**MOUNT POLLEY MINING CORPORATION
MOUNT POLLEY MINE
TAILINGS STORAGE FACILITY**

**REPORT ON 1999 CONSTRUCTION
(REF. NO. 11162/13-5)**

REPORT ON 1999 CONSTRUCTION

FIGURE 1

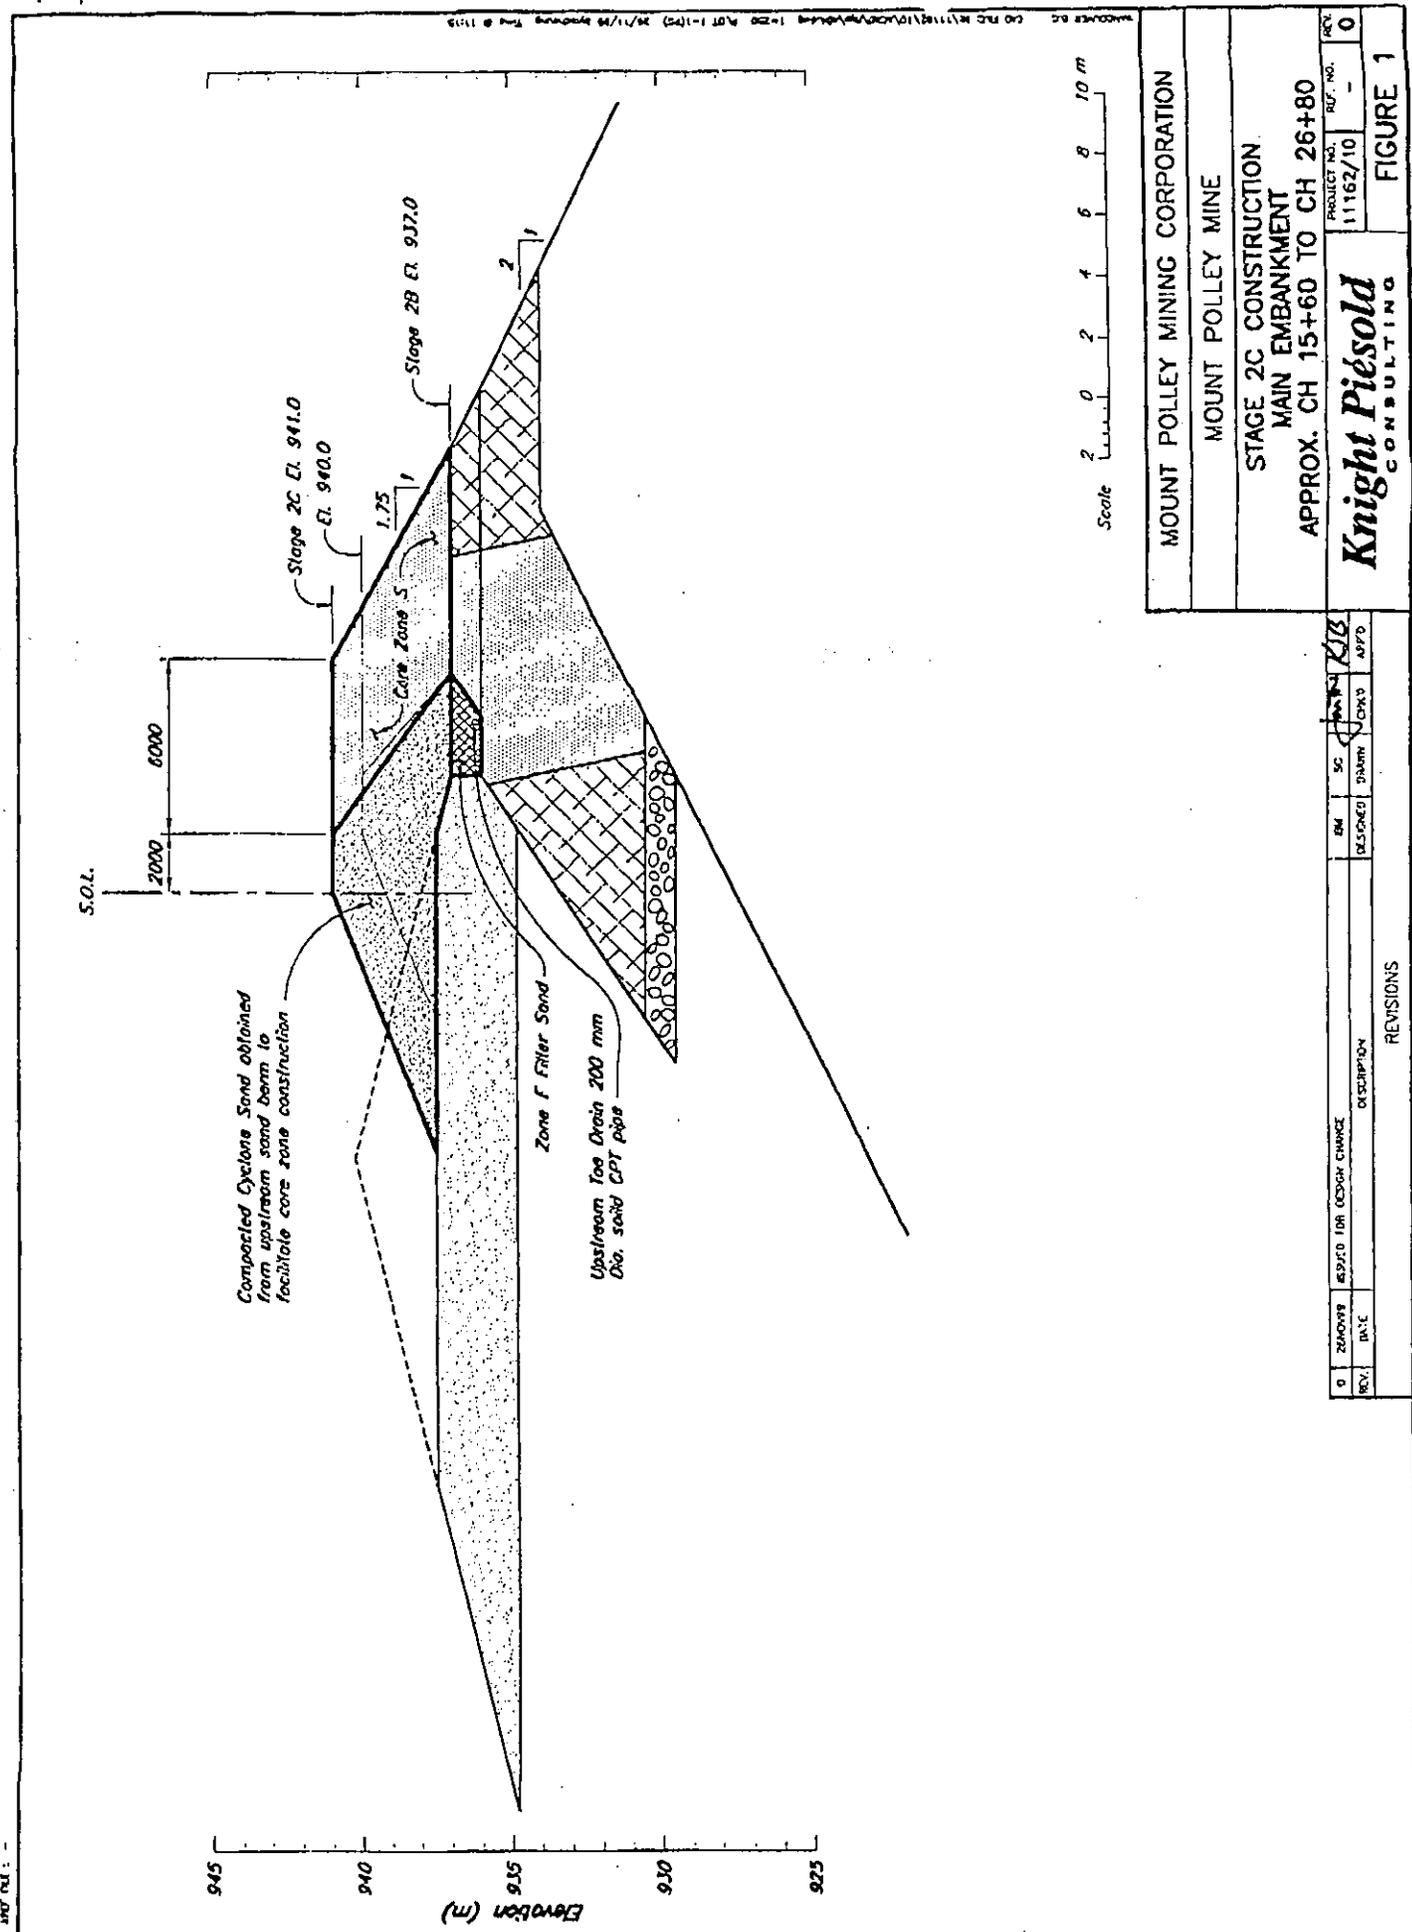
GENERAL DESCRIPTION OF CHANGE: Design change for tailings facility embankments from crest El. 940m to El. 941m

Reference Drawings/Clauses: Figure 1 - Main Embankment (± CH 15+60 to 26+80)
Figure 2 - Main & Perimeter Embankments (± CH 26+80 to 32+00)
Figure 3 - Perimeter Embankment (± CH 32+00 to 44+35)

FIGURE 1

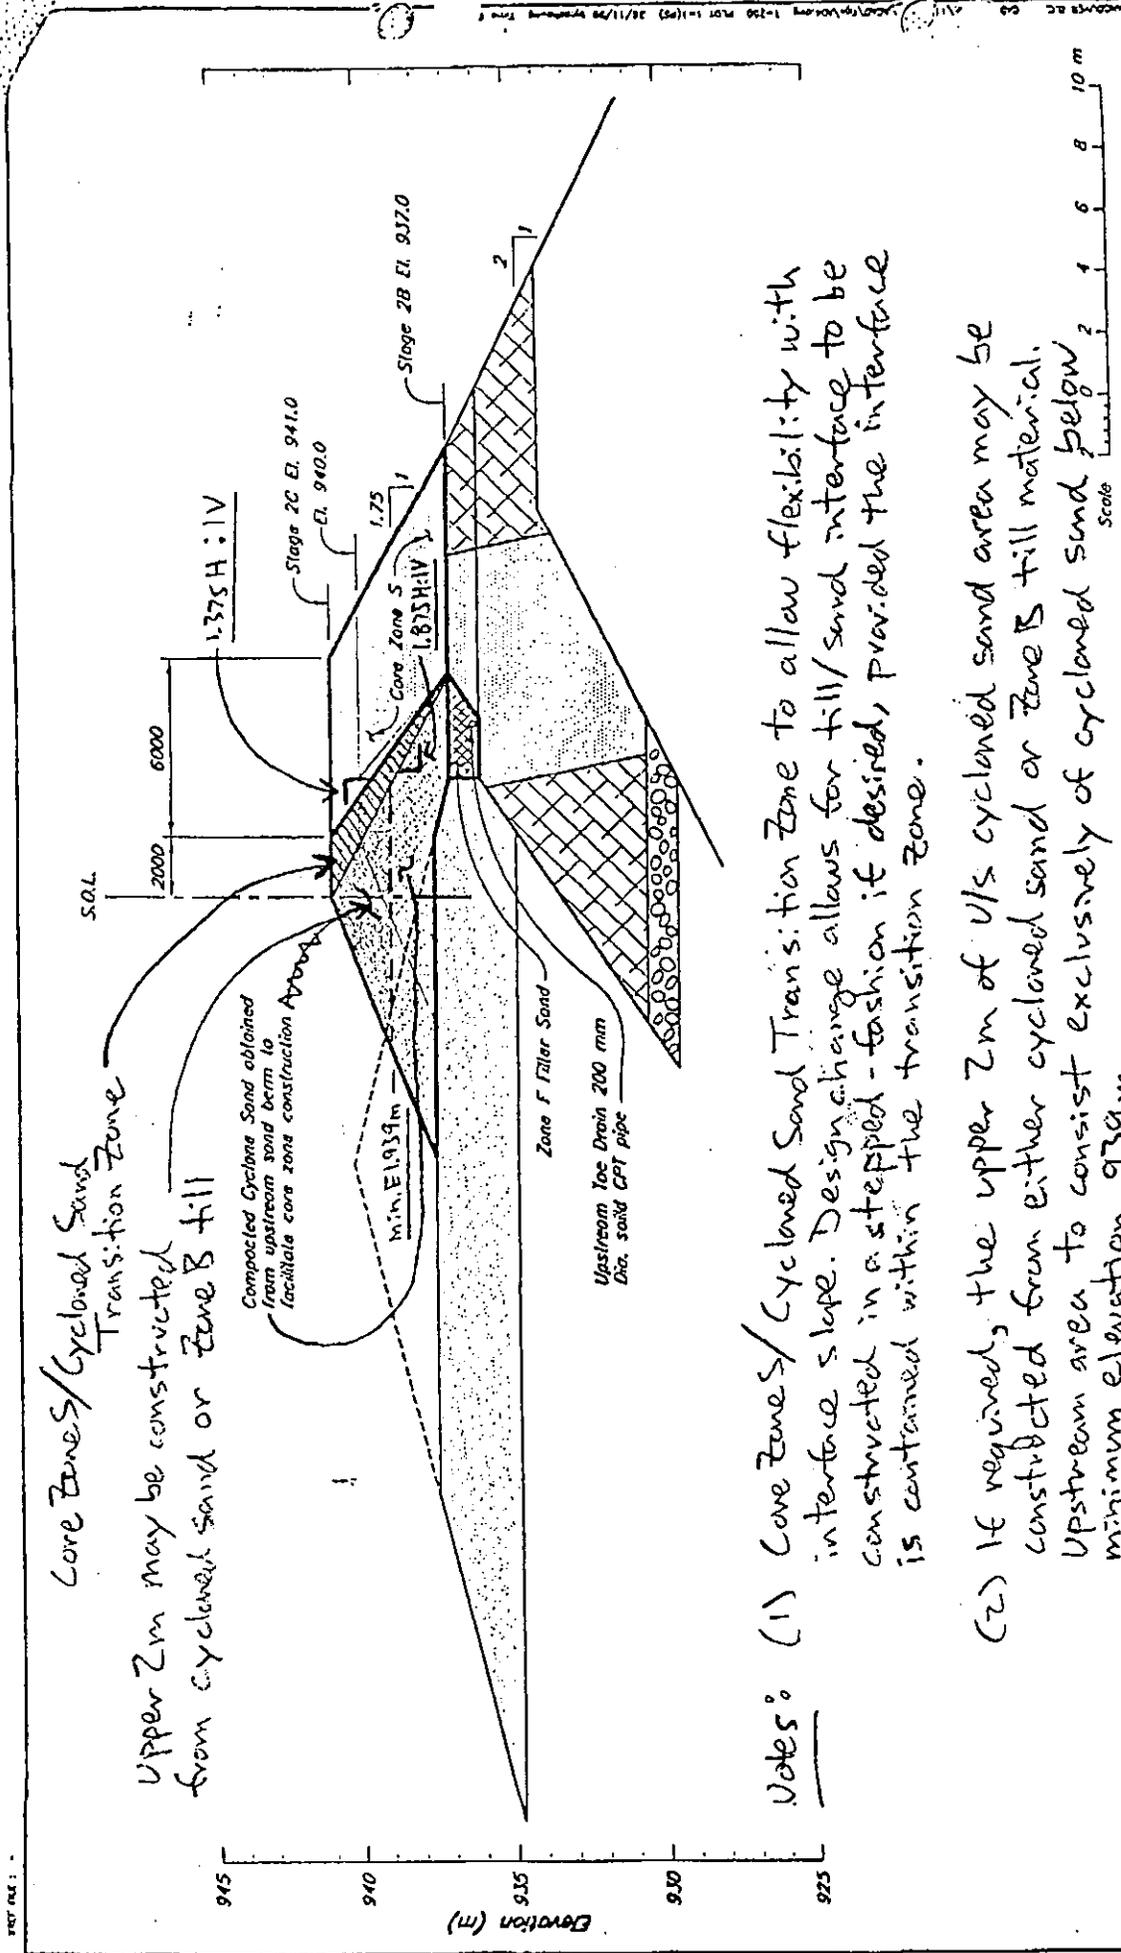
Reference Drawings / Clauses: Figure 1 Rev. 0 of Design Change, issued by KP Vancouver (Nov 26/99, Ref No. 9/2771)
